The Sizewell C Project

5.6 Sizewell Link Road Flood Risk Assessment Addendum Appendices

APPENDIX B: Collated comments from the Environment Agency received on 5th February 2020, 4th August 2020, 14th September 2020 and 30th April 2021

APPENDIX B: COLLATED COMMENTS FROM THE
ENVIRONMENT AGENCY RECEIVED ON 5TH FEBRUARY
2020, 4TH AUGUST 2020, 14TH SEPTEMBER 2020 AND 30TH
APRIL 2021

Plate 2.42.4: Cross-section of portal culvert at crossing 1 (extract from drawing no. SZC-AD0310-WSP-SLRHDG-ZZ0000-DRW-HCD-300002)

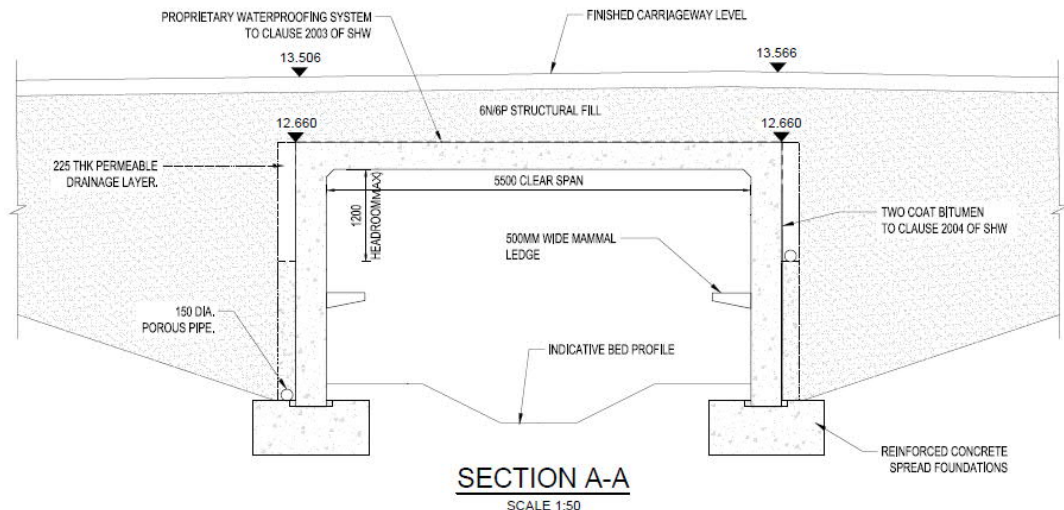
1	Hydraulic model for Crossing 1 & 2	N/A	Discrepancy between culvert dimensions in the hydraulic model at crossing 1 and the reported dimensions as shown in Plate 2.4 of the Addendum modelling report	There is a discrepancy between the dimensions for Crossing 1 as shown in Plate 2.4, page 8 of the Addendum modelling report and those in the hydraulic model (SW1-CulvUS). The culvert soffit level shown in the Addendum report is higher than the culvert soffit in the hydraulic model	Please check the dimensions in Asymmetrical conduit unit SW1-CulvUS and correct the report and/or hydraulic model depending on which is correct	1	30/04/2021	-	-	-	A simplified representation of the portal culvert was adopted in the model, which resulted in a lower soffit level when compared with the cross-section drawing presented in Plate 2.4. However, the peak flood levels within the culvert for the most extreme scenario, i.e. the 1 in 1,000-year+65%CC event is below the adopted soffit level in the model. Therefore, there is no impact on the modelling results or conclusions presented in the FRA Addendum. Further clarification on the simplified representation of the portal culvert in the model and Plate demonstrating that extreme water levels don't reach the lower soffit have been added to the Modelling Report Addendum and the FRA Addendum in the relevant results sections.

3	Sizewell C Sizewell Link Road Flood Risk Assessment Addendum - Appendix C: Modelling Report Addendum	Section 2.2.19, page 8	The report states that "The levels presented in Plate 2.4 are indicative levels only and are subject to change within the hydraulic model and the final design as it progresses into detailed design stage, where more detailed information of the existing ground level would be obtained."	Are the levels shown in the hydraulic model reflective of the final design for crossing 1? If they are subject to potential further change how can we ensure that this won't adversely affect flood risk if the current modelling is only indicative	Please confirm that the dimensions for crossing 1 (SW1-CulvUS) and 2 (SW2-4ACUS) within the hydraulic model (SLR_Road_SW1_07.dat) are reflective of the final proposed design	1	30/04/2021	-	-	-	The dimensions of the portal culverts within the models reflect the latest (at the time of the assessment) proposed design. It is possible that minor changes may arise at the detailed design stage. However, the design principle and overall capacity of the culverts would not be reduced and therefore would not have an impact on the results of the modelling undertaken and subsequently the conclusions of the FRA. Clarification has been added to the Modelling Report Addendum in the relevant section.

Plate 2.52.5: Long-section of the diverted channel (extract from drawing no. SZC-AD0310-WSP-SLRHDG-ZZ0000-DRW-HCD-300101)

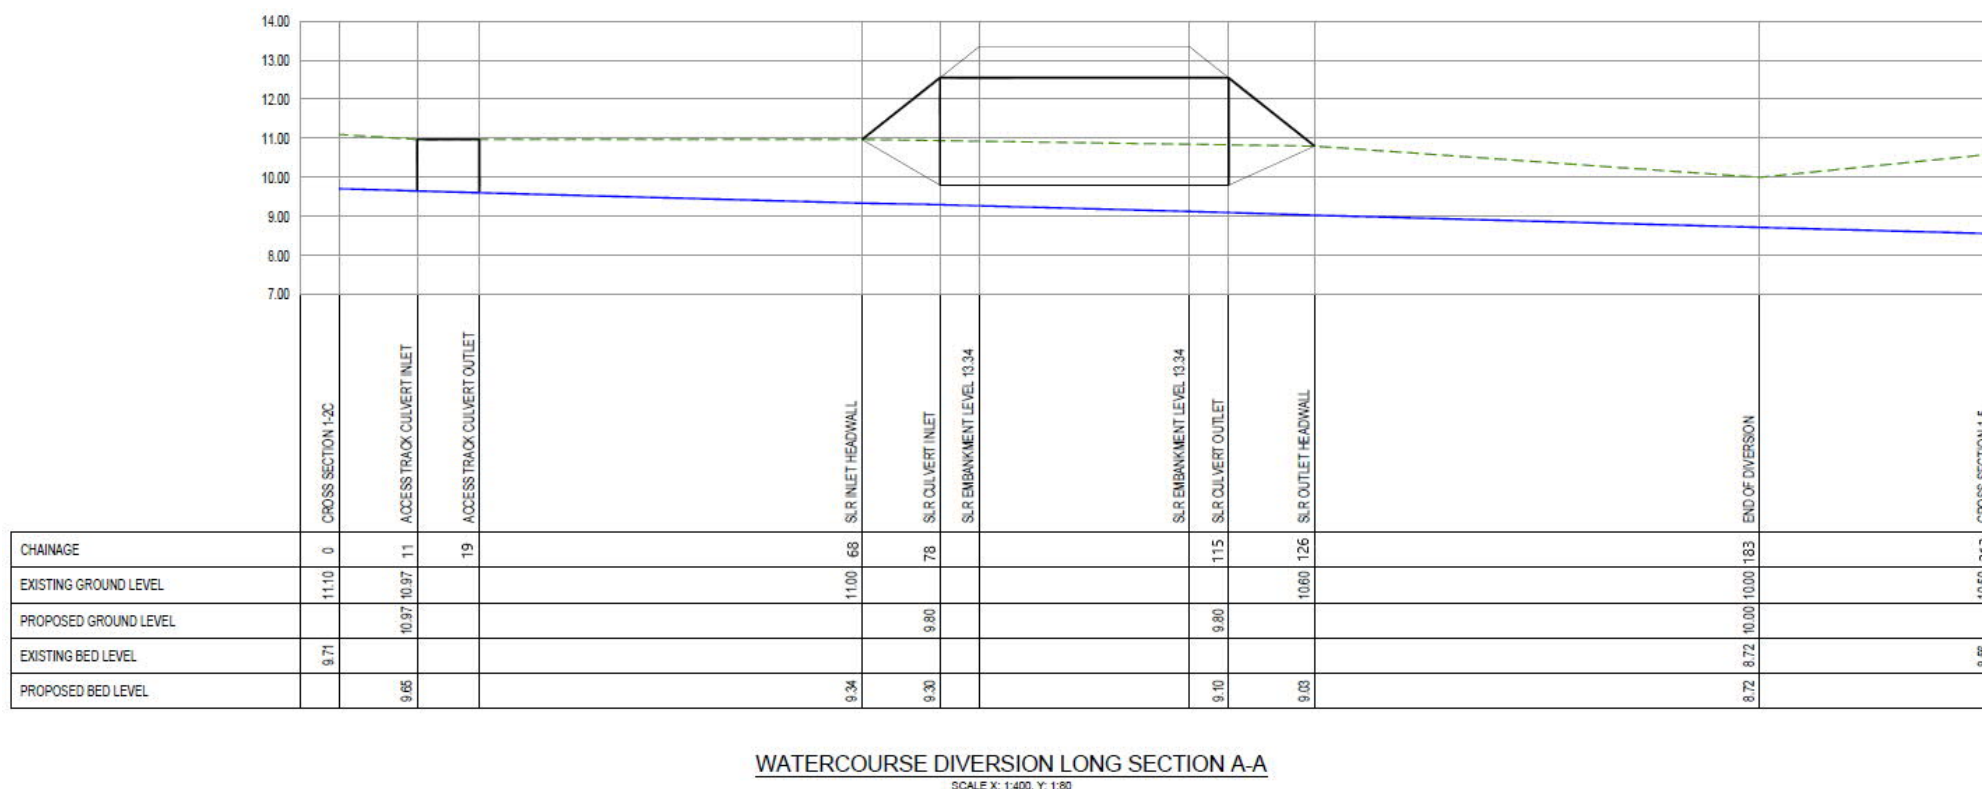
6.1	Sizewell Link Road Fluvial Modelling Report	Plate 2.5	The proposed cross section of the new diversion channel at SW1 is substantially larger than the current watercourse.	The cross section of the existing watercourse is understood to be approximately 1.5m² this drawing shows the top of the channel to be 9.4m wide which is much larger. The FRA also does not explain how the channel will be constructed. The new channel should be as natural as possible.	Please explain why the cross section shown has been chosen and why it does not replicate the existing channel. Provide cross sectional survey obtained to show existing channel dimensions to provide a comparison to the proposed design.	1	05/02/2020	Further details of the design of the re-aligned channel have been provided in the Modelling Report Addendum and the FRA Addendum.	The modelling cross sections show that the existing channel has dimensions of 5.5m top width and 1.5m deep, with very narrow bed, and an approximate cross-sectional area of 4m². The proposed channel has a bed width of 1m, top width of 10m, height of 1.5m and cross-sectional area of approximately 10m², so more than double the existing channel area. It appears that the proposed channel is trapezoidal. From a biodiversity perspective we would rather see a stepped marginal plant ledge on at least one side of the watercourse, on the lengths of watercourse either side of the crossing, in order to ensure that there is a vegetated area in the watercourse. The proposed mammal ledge must be raised above the 1% flood level, but it is not clear whether this is the case, so this should be clarified by showing the flood extents on the portal culvert cross section.	Not yet. Realigned channel should be designed with a marginal stepped ledge, and cross sections of portal culvert should be provided.	The design has considered current guidance on the required width of the watercourse and the mammal ledge, i.e. 1 in 3. A channel incorporating a stepped ledge can be considered at the detailed design stage, however it would be designed such that it would maintain conveyance capacity of the channel and therefore it would not have an impact on the existing conclusions set out within FRA Addendum or the accompanying Modelling Report Addendum.

Plate 2.6.6: Cross-section of portal culvert at crossing 2 (extract from drawing no. SZC-AD0310-WSP-SLRHDG-ZZ0000-DRW-HCD-300005)

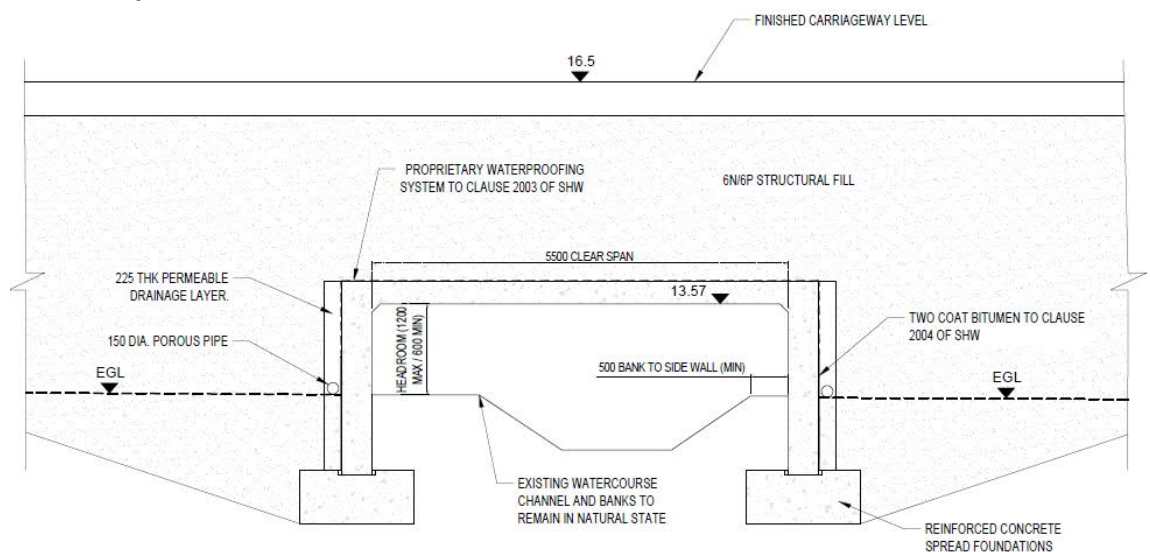
6.2	Sizewell Link Road Fluvial Modelling Report	Plate 2.6	SW1 crossing is now a T shaped concrete culvert. Material will be added to the bed and banks to naturalise the channel.	It is assumed that the cross sectional area shown in plate 2.6 and the model includes any material required to naturalise the culvert. This material could reduce capacity and impact on model results so must be included. It is not explained how or what sort of material will be used to create a natural bed and banks.	Confirm material will not reduce the capacity of the culvert and if it will this must be reflected in the modelling. Provide details on the material to be used to naturalise the bed and banks so we can determine it is suitable.	1	05/02/2020	Further details and clarification on the design and capacity of the culvert have been included in the Modelling Report Addendum.	T-shaped culvert has been replaced with a portal culvert.	Yes	N/A

2	Hydraulic model for Crossing 1 & 2	N/A	Discrepancy between culvert dimensions in the hydraulic model at crossing 2 and the reported dimensions as shown in Plate 2.6 of the Addendum modelling report	There is a discrepancy between the dimensions for crossing 2 in the model (SW2-4ACUS) and those shown in Plate 2.6 of the addendum report	Please check the dimensions in Asymmetrical conduit unit SW2-4ACUS and correct the report and/or hydraulic model depending on which is correct	1	30/04/2021	-	-	-	Plate 2.6 shows an indicative cross-section of the portal culvert. The soffit level of 13.57mAOD has been included within the model which matches the drawing presented in Plate 2.6. The drawing notes that there is a minimum of 500mm between the side wall and slope in profile to the channel for mammal passage. In the model (based on the ground levels obtained from the survey) this was set to approx. 1.05m. The drawing also notes that the ledge on the left side of the channel is determined by existing ground levels but a headroom of between 0.6m and 1.20m should be maintained. The cross-section in the model is therefore consistent with the design principles but takes into consideration existing ground levels (from the survey) and therefore looks slightly different than the indicative cross-section provided on the drawing in Plate 2.6. Clarification has been added to the Modelling Report Addendum and the FRA Addendum in the relevant sections.

Plate 2.72.7: Plan view of crossing 3 (extract from drawing no. SZC-AD0310-WSP-SLRHDG-ZZ0000-DRW-HCD-300006)

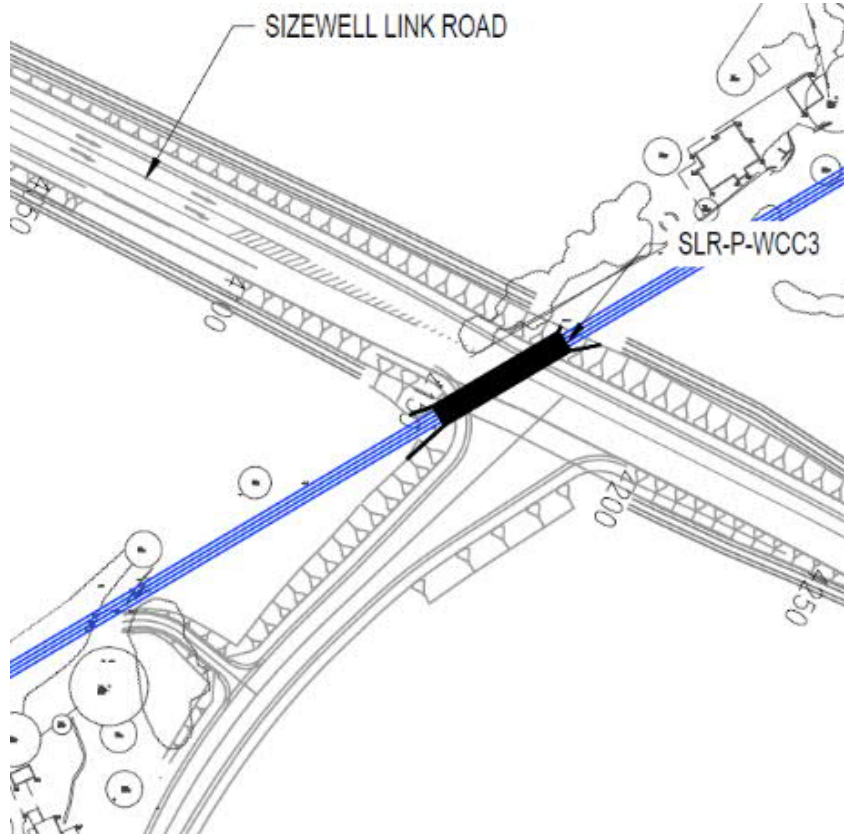
4.5	Sizewell Link Road Flood Risk Assessment	Plate 2.7	The proposed layout of SW3 is provided in plate 2.7, although this is not clear and appears unfinished.	It is not clear from the FRA or model report what the final design for the SW3 crossings are. It is understood an existing culvert will be extended with a portal culvert under Hawthorn Road and a flood relief culvert will also be installed. The description of the SW3 design in 2.2.21 does not appear to be consistent with the drawing in Plate 2.7	Provide clear plans and drawings for SW3 showing the existing and proposed arrangement. The information provided so far is not clear. Update the text to provide clarity and justify the final design in consultation with Suffolk County Council as it is an ordinary watercourse.	2	05/02/2020	Further design details (where available) have been discussed in the FRA Addendum.	The flood relief culvert has been removed as it is not considered necessary. The modelling shows that Hawthorn Road is already at risk of flooding to 0.5m deep in the 1% with 35%cc event downstream of Hawthorn Cottages. The cottages are not at risk of flooding as the properties are situated 0.18m above the maximum 0.1% with 65% climate change flood level. With the proposed culvert modelled, this results in increased flood depths, by up to 0.22m increase in the 1% (1 in 100) with 35% climate change. The resulting area of increased flood depths is mostly limited to the strip of land between the existing Hawthorn Road and the connection road to the Sizewell link road, for a distance of 40m upstream, as shown on Plate 4.12. The land owner should be contacted and agreement sought for the increase in flood depths. 4.3.16 states that the increased flood depth area is within the site boundary, so perhaps this won't be necessary. However as it is a small area of increase, then it is hoped that this would be acceptable. This increase does not have any impact on Hawthorn Cottages, as the modelling shows no increases in flood depths in the river adjacent to the properties in all flood events. The FRA Addendum presents the results of the range of climate change flood events for the 1:20, 1:100 and 1:1000 scenarios, ranging from 0.08m increase for the 1:5 year cc event, to 0.29m for the 1:1000 cc event, all just upstream of the proposed culvert. However, it would be good to see the results for the present day scenarios, just to check that they are no worse in terms of increases in flood depths. In the extreme 0.1% (1 in 1000) flood event with 35 or 65% climate change, the maximum increase of flood depths is experienced at 0.29m. However this is considered acceptable as it is an extreme event.	Mostly - it would be good to confirm if landowner agreement needed for area of increased flood depths, or if not necessary as in site boundary. Present day flood event increases should also be provided.	The change in flood depth is limited to the area within the red line boundary and therefore it is considered acceptable for the Project.

5.9	Sizewell Link Road Fluvial Modelling Report	Plates 2.4 and 2.7	Plate 2.7 does not show where the flood relief culverts for crossing SW3 will be located. It is not clear how the locations of the proposed flood relief culverts relate to the modelled floodplain/outlines.	Plate 2.4 shows SW1 box culvert runs adjacent to portal culvert. A box culvert is shown on Plate 2.7 for SW3, but this is not clear. There is no mention of a portal culvert. Is this plan incomplete?	Provide updated final design arrangement plans and cross sectional drawings for SW1 to SW7.	2	05/02/2020	Further design details (where available) have been discussed in the Modelling Report Addendum.	Flood relief culvert for SW3 has been removed. SW1 no longer has a box culvert, instead the watercourse is realigned, with mammal passage provided in the portal culvert which will need to be cut into the banks.	Yes.	N/A
6	Sizewell Link Road Fluvial Modelling Report	Plate 2.4	The surface water infiltration basin to the east of Fordley Road at SW1 is located on higher ground. As the surface water drainage design is not available it is difficult to understand how the road will drain to the infiltration ponds.	The field to the east of Fordley road where the infiltration basin is located is higher ground. Surface water is known to run off and drain to the low point at Fordley Road. The FRA should consider how to improve this in the first instance and must not increase flood risk as a result of the development.	Provide information on surface water drainage to Suffolk County Council. Evidence that flood risk will not be increased and where possible it has been reduced overall in line with paragraph 5.7.3 of National Policy Statement EN1 and paragraph 160 of the National Planning Policy Framework.	2	05/02/2020	Further details on surface water drainage design (where available) and flood risk have been provided in the FRA Addendum.	This is not specifically mentioned in the FRA Addendum. The height of the land in the location of the proposed basin varies from 1.2m AOD to 18m AOD, so it is unclear how the road will be able to drain to the attenuation basin here, since the road will be at a high of 13.5m AOD as it goes over the river. We assume that the attenuation basin will be cut into the ground to provide the required storage.	Not specifically addressed in Addendum. Issue for LLFA.	The next iteration of the Sizewell Link Road drainage design strategy is due to be issued into Examination. This document would take precedence over the text contained within the FRA Addendum.

Plate 2.8-8: Cross-section of portal culvert at crossing 6 (extract from drawing no. SZC-AD0310-WSP-SLRHDG-ZZ0000-DRW-HCD-300008)

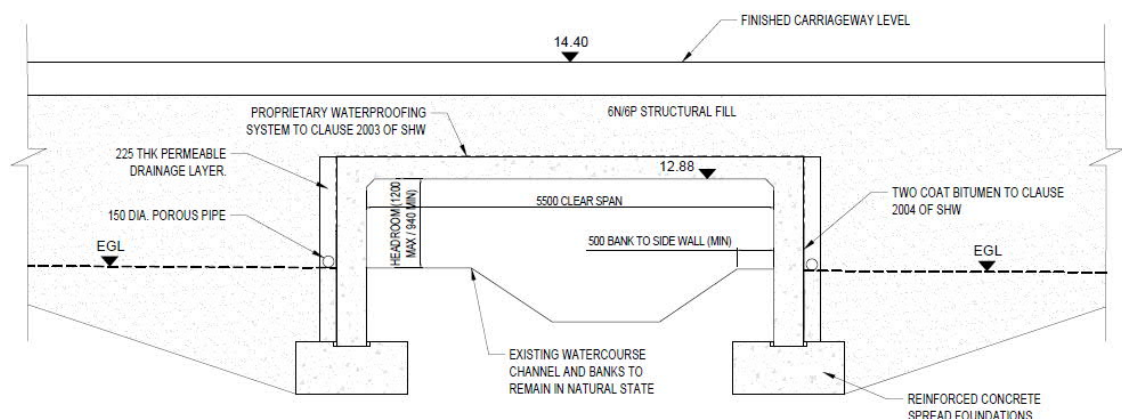
4	Hydraulic model for Crossing 6	N/A	Discrepancy between culvert dimensions in the hydraulic model at crossing 6 and the reported dimensions as shown in Plate 2.8 of the Addendum modelling report	The dimensions for the proposed portal culvert within the hydraulic model (SW6-CulvUS) do not align with the section shown in plate 2.8 of the modelling report	Please check the dimensions in Asymmetrical conduit unit SW6-CulvUS and correct the report and/or hydraulic model depending on which is correct	1	30/04/2021	-	-	-	The dimensions of the portal culvert in the model match the design drawing i.e. the width and soffit levels are the same. The drawing shows the indicative headroom between the river bank/mammal ledge and the soffit of the culvert to be between 940mm and 1200mm. However, it is noted that the cross section provided is taken from the middle section of the portal culvert. Depending on the existing ground levels at the upstream and downstream end of the culvert, the headroom may be reduced (to approx. 600mm), as is represented within the model. Therefore, the model does represent the design principles correctly. Clarification has been added to the Modelling Report Addendum and the FRA Addendum in the relevant sections.

Plate 4.94.8: Location of the key model nodes on crossing 3

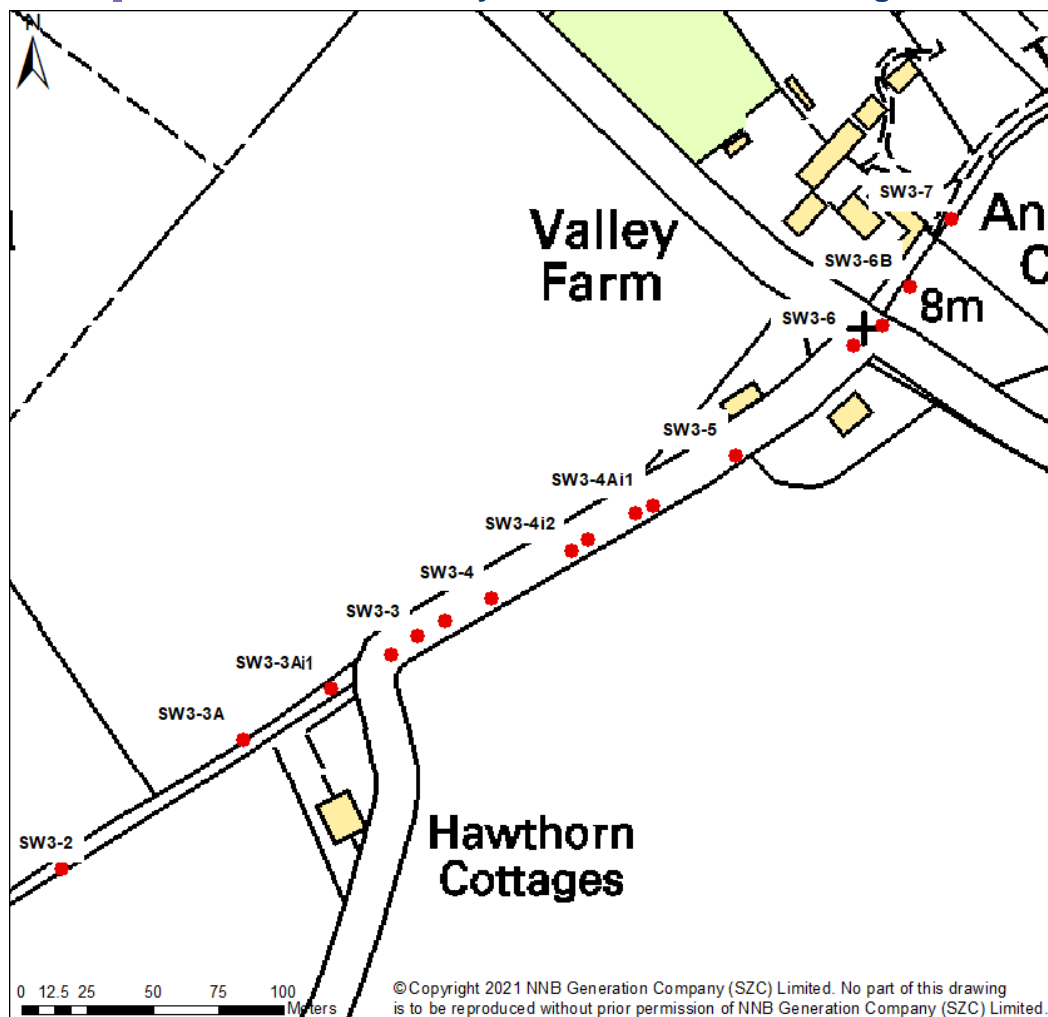
7	Sizewell C Sizewell Link Road Flood Risk Assessment Addendum - Appendix C: Modelling Report Addendum	Plate 4.9, Page 53	Discrepancies between long section bed profile shown in Plate 4.9, page 53 and what is shown in the hydraulic model for Crossing 3 (SW3)	The Long section in Plate 4.9, page 53 of the Addendum report shows an odd 'drop' in bed profile between SW3-41 and SW3_C.ds which is not reflected in the hydraulic model (SLR_Road_SW3_NoBox_D2.dat).	Please correct the long section in the reporting	2	30/04/2021				<p>The 'drop' in bed profile is a visual / display issue only and is a result of the limitations within the Flood Modeller software which doesn't display exact invert levels within asymmetrical culverts.</p> <p>Long section plots have been updated (outside of Flood Modeller software) and demonstrate that the bed levels are correctly represented in the model. This updated long section plot has been included within the updated FRA Addendum.</p>
